Access Compliance Report

Public Rights-of-Way (Curb Ramps)

Intersection ID: 52926	Main Street: WALTHAM_LN	Cross Street: EMORY_OAK_DR	Location: SE
ADA ID: 7A2991D66A31	Ramp Type: Perp	Initial Pass/Fail: Pass	Overall Compliance: No
Severity Score: 5			
Codes/Mitigation Info/Possible Solution		Field Measurements/Component Compliance

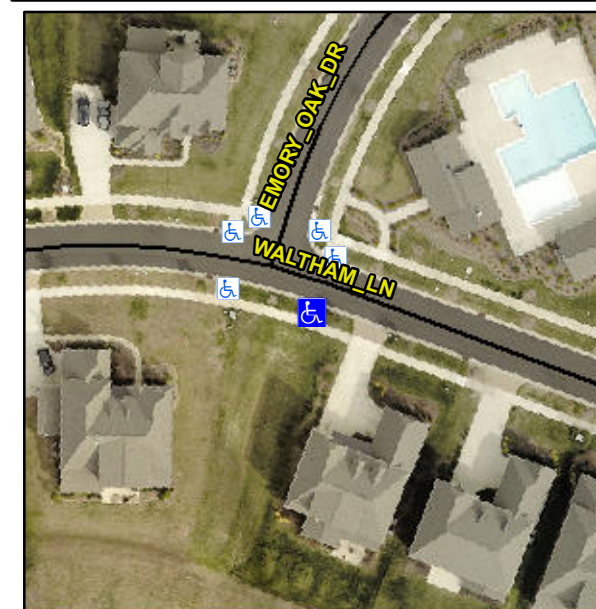
**R304.2.2-Perp, R304.3.2-Para,
R304.2.3, R305.2**

Compliance	Description	Data	Compliance	Description	Data
N/A	Ramp Length (in)	95.5	Yes	Ramp Slope (%)	5.9
Yes	Ramp Width (in)	60.5	Yes	Ramp XSlope (%)	1.7
N/A	Flare Type LT	Sloped	N/A	Flare Type RT	N/A
N/A	Flare Slope LT (%)	6.1	No	Flare Slope RT (%)	12.7
N/A	Flare Traversable LT?	Yes	N/A	Flare Traversable RT?	Yes
Yes	Landing Length (in)	60.5	Yes	DWS Provided?	Yes
Yes	Landing Width (in)	60.5	Yes	DWS Contrast?	Yes
No	Landing Slope (%)	2.8	Yes	DWS Length (in)	24.0
Yes	Landing X Slope (%)	2.0	Yes	DWS Full Width?	Yes
N/A	Landing Curb? (Y/N)	No	No	DWS Offset (in)	5.5
N/A	Shared Landing?	No			
Yes	Gutter Ponding?	No	Yes	Gutter Slope (%)	4.6
Yes	Gutter Lip Ht (in)	0.0	Yes	Gutter X Slope (%)	1.0
N/A	Painted X Walk1?	No	N/A	Painted X Walk2?	N/A
	X Walk 1 Direction	To N		X Walk 2 Direction	N/A
N/A	X Walk 1 Width (in)	N/A	N/A	X Walk 2 Width (in)	N/A
	X Walk 1 Slope (%)	3.6		X Walk 2 Slope (%)	N/A
	X Walk 1 X Slope (%)	1.2		X Walk 2 X Slope (%)	N/A

Remove & Replace Entire Ramp.
